FOREST HEIGHTS COLLEGIATE INSTITUTE
TECH. SHOP REVITALIZATION AND WINDOW
REPLACEMENT

TENDER # 25-7636-RFT
255 Fischer-Hallman Rd,
Kitchener, ON N2M 4X8

RESUBMITTED FOR BUILDING PERMIT

3 PARTIAL EXISTING SECOND FLOOR - FAN ROOM
SCALE - 1:125

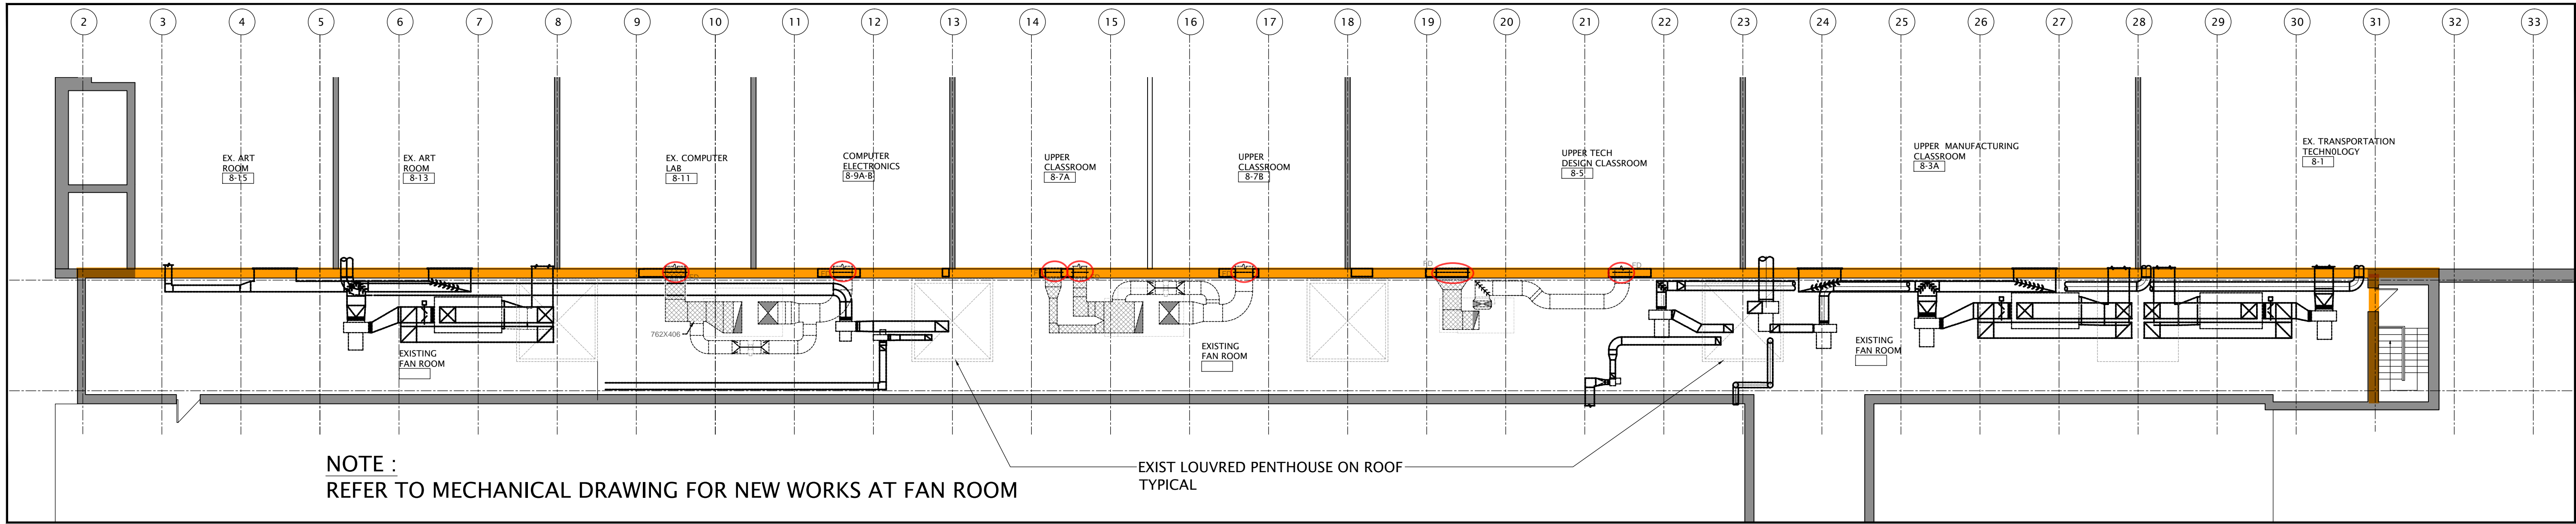
FIRE DAMPERS REQUIRED AT DUCT PENETRATIONS
THROUGH RATED FIRE SEPARATIONS.

2 PARTIAL FRAMING PLAN
S1.0 1:50

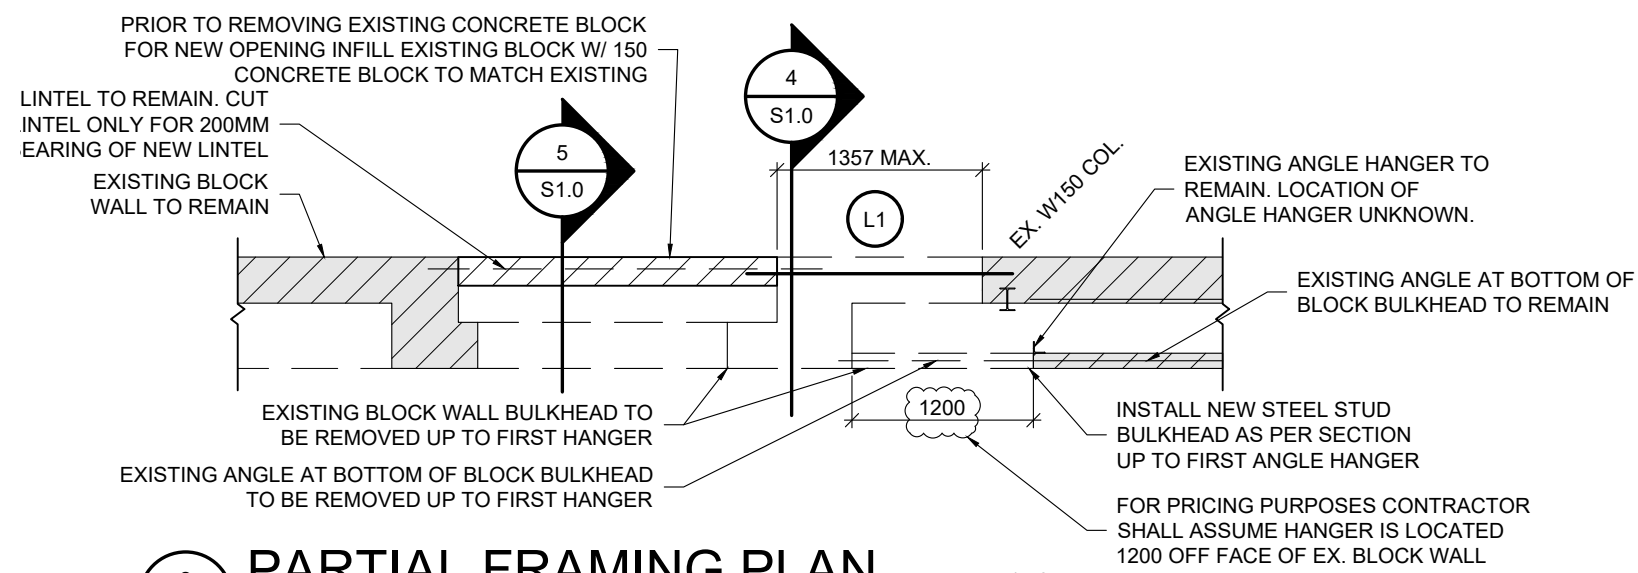
PROVIDE STRUCTURAL STEEL SHOP DRAWINGS TO BUILDING INSPECTOR PRIOR TO INSTALLATION.

STAFF ROOM - ELECTRICAL LAYOUT

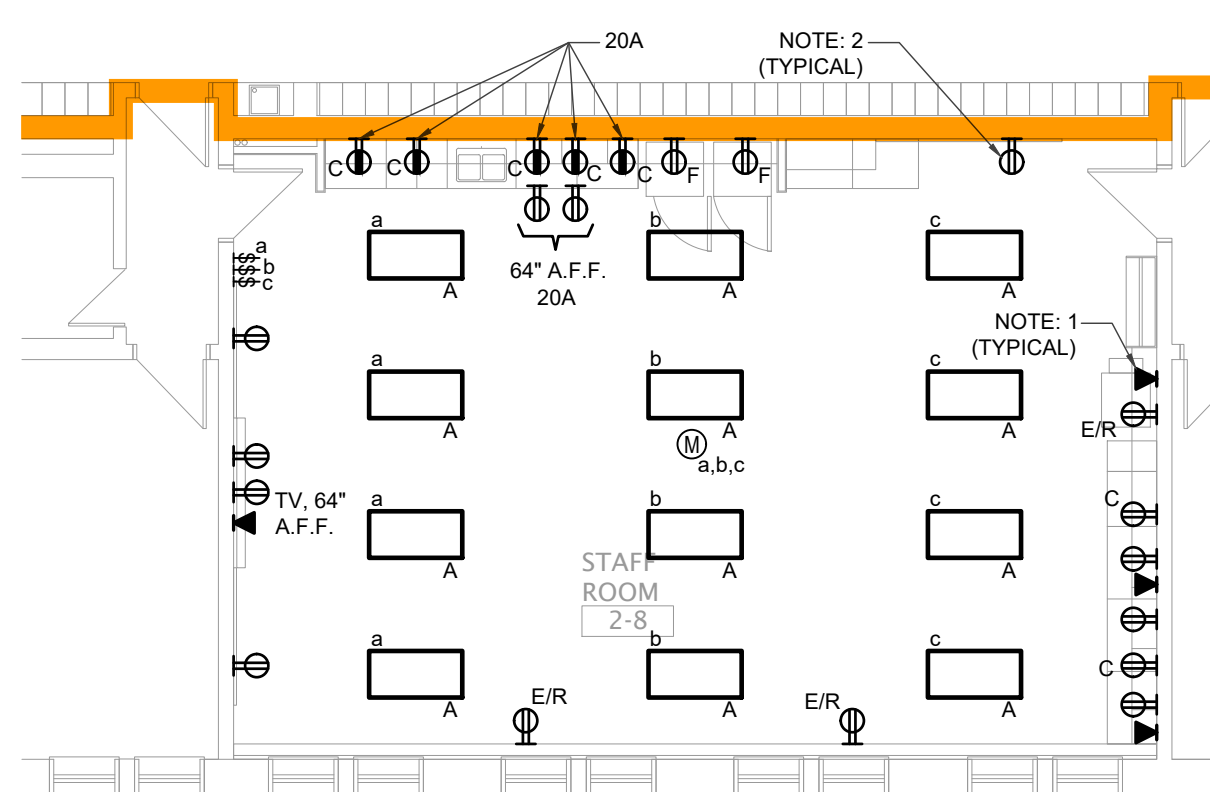
POWER DOOR OPERATOR PUSH BUTTONS SHALL BE LOCATED NOT LESS THAN 600mm AND NOT MORE THAN 1500mm BEYOND THE DOOR SWING WHERE THE DOOR OPENS TOWARDS THE CONTROL AS PER OBC DIV B, 3.8.3.3.(17)(d).
